# KERR-MCGEE CORPORATION

Please refer to your letter dated August 24, 1982 outlining additional requirements (3 items) for the Kerr-McGee Nuclear Corporation Sequoyah facility injection well permit. These items are addressed below:

MONITORING WELL SPECIFICATIONS  
KERR-McGEE SEQUOYAH FACILITY  
GORE, OKLAHOMA

PROPOSED MONITOR WELL  
SEQUOYAH FACILITY

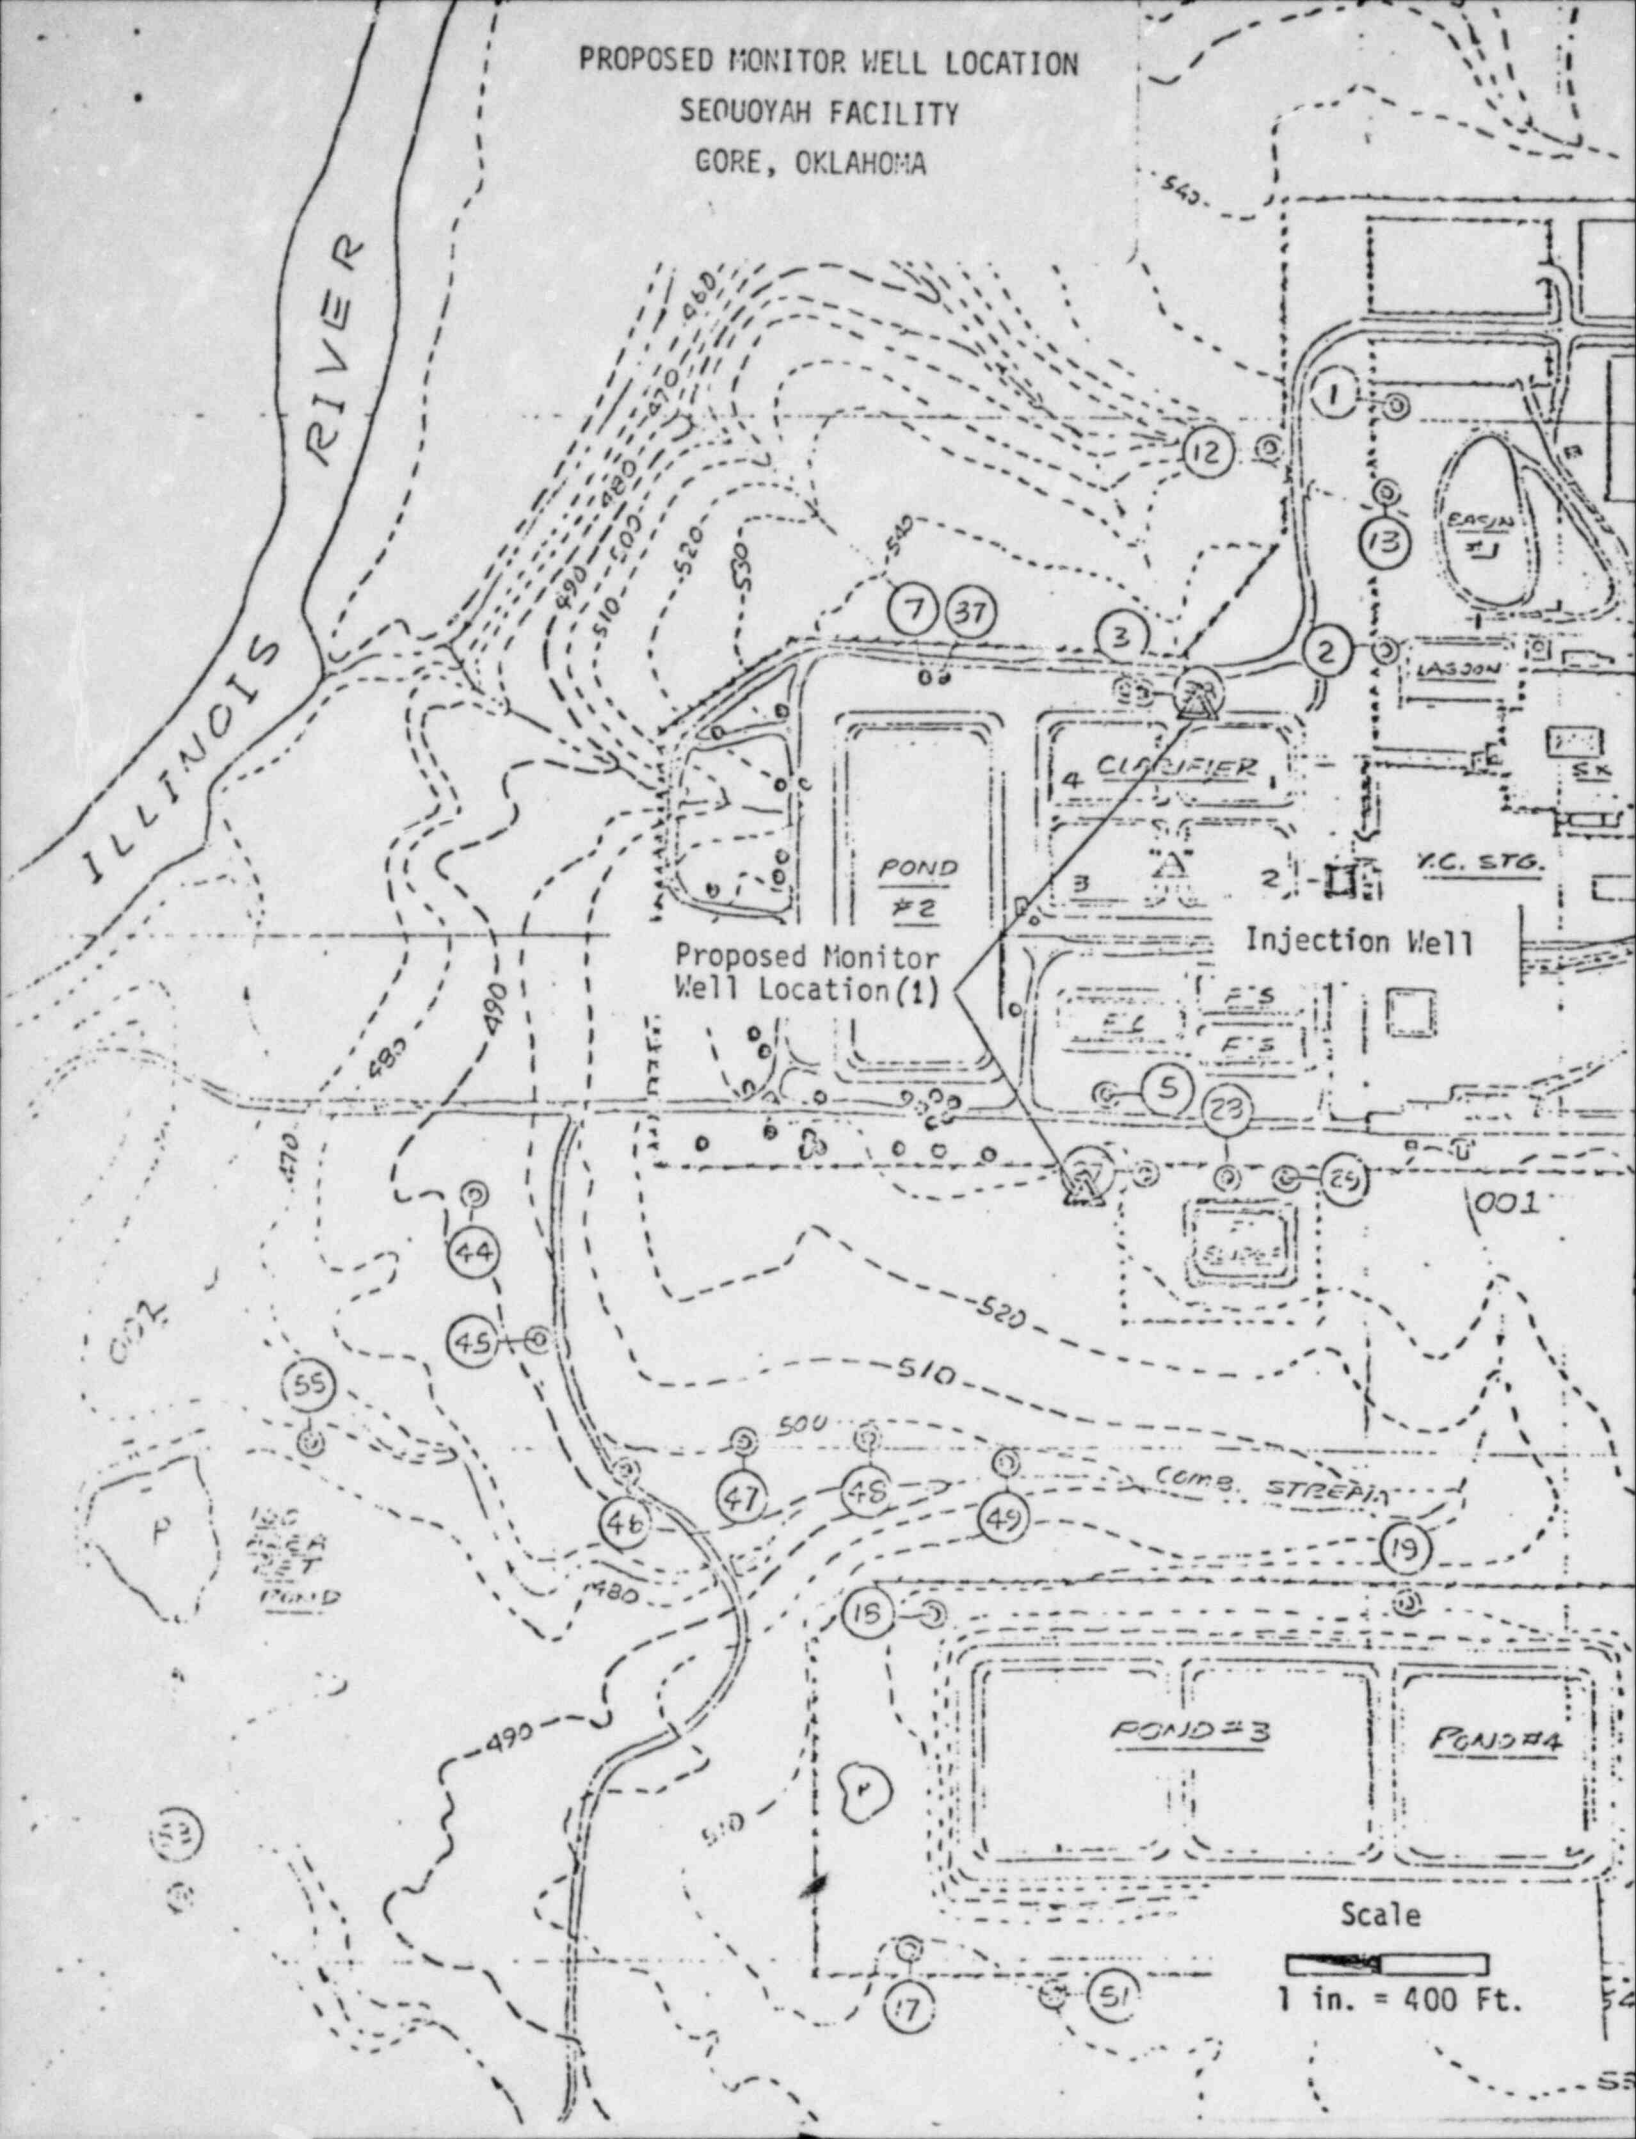
The location described above requires that the well be placed in the space between the raffinate clarifier and the fluoride clarifier. This area is crowded with buried pipelines and utility conduits and will shortly be a construction area for the installation of a new facility. We therefore request that the distance from the injection well be extended to approximately 800 feet southwest or approximately 300 feet to the northwest of the injection well so as to place it in an area where it will be undisturbed.

Based upon our review of the lithology, Kerr-McGee believes that water exceeding 10,000 mg/l TDS may be encountered at a depth of less than 400 feet. Therefore, we request that the condition be changed to read that the depth requirement read 400 feet or at a depth where saltwater is encountered during drilling.

Construction methods and a map which shows the preferred location for this monitor well are attached. At this time, in compliance with OSDH Rules and Regulations Part 7F.5.5, Kerr-McGee requests that these specifications be approved by your Department, as required, prior to monitor well installation. Please advise.

Well Materials: (See Figure)

Surface casing - Normal 10" diameter, 0.25" wall, steel casing will be set from surface to a depth of approximately 100 feet. This casing is to be pressure grouted (water displaced) with cement return to surface.

Well Casing - Nominal 4" diameter, 0.237" wall, Schedule 40, PVC casing with threaded couplings will be set from surface to a depth of approximately 300 feet or as determined by field conditions.

Well Screen - Nominal 4" diameter, 0.237" wall, 100 slot PVC screen with threaded couplings will be set from approximately 300 feet to total depth or 400 feet as determined in the field.

Gravel Pack - Fine (2mm-8mm) clean quartz gravel will be placed by tremie pipe from bottom of hole to 20 feet above the top of the well screen.

Bentonite - A bentonite slurry will be placed from the top of the gravel to 1 foot below grade. Portland cement will be placed from top of bentonite to grade.
